Design change affecting tensioning pulley 531 0203 20

INA 0049

Image 1: 531 0203 20 – previous design

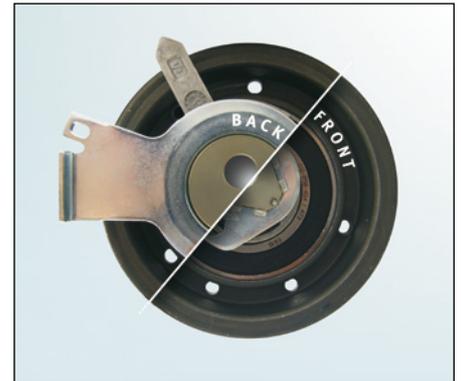
Due to the constant development of our products, the design of tensioning pulley 531 0203 20 has been changed. This Service Information sheet shows the visible differences between the two versions from the front and back of each tensioning pulley.

The special tool (OE no. T10020) for turning the eccentric is no longer needed. Please use a 6 mm allen key.

We may have mixed stocks during the transitional phase. Both tensioning pulleys meet the technical specifications and can be used without restrictions on the specified vehicles.
